DUKE COGEMA  
STONE & WEBSTER

02 November 2001  
DCS-NRC-000069

Subject: Docket Number 070-03098  
Duke Cogema Stone & Webster  
Mixed Oxide Fuel Fabrication Facility  
Response to Request for Clarification

**Figure 5.4-1: Safety Assessment of the Design Basis**

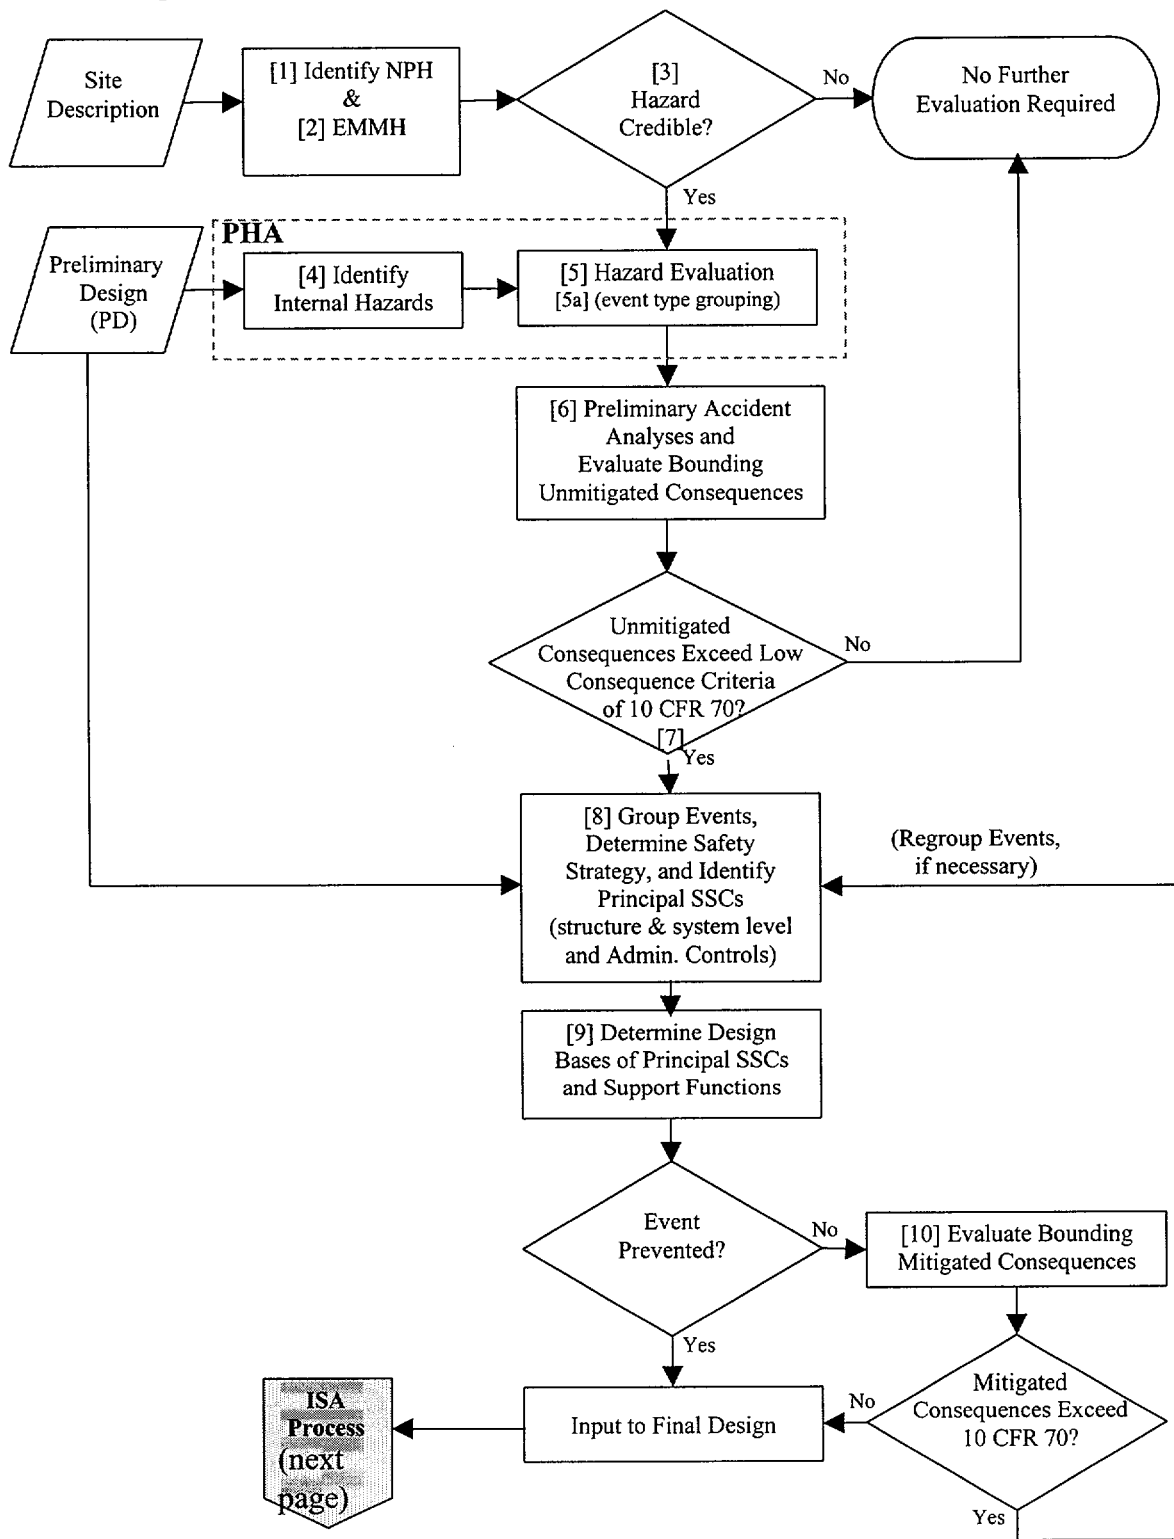
During review of Duke Cogema Stone & Webster's (DCS') Mixed Oxide Fuel Fabrication Facility (MFFF) Construction Authorization Request (CAR), NRC staff requested a clarification of the ISA process described in CAR Figure 5.4-1 that correlates the figure to the tables in CAR Chapter 5 and the internal supporting documentation. This correlation is provided in Enclosure A. If you have any questions, please contact me at (704) 373-7820.

The attached figure provides a cross-reference from the actions in Figure 5.4-1 to the tables in chapter 5 and the supporting DCS calculations. Sample hazard identification, hazard evaluation, and consequence evaluation sheets are also provided for information.
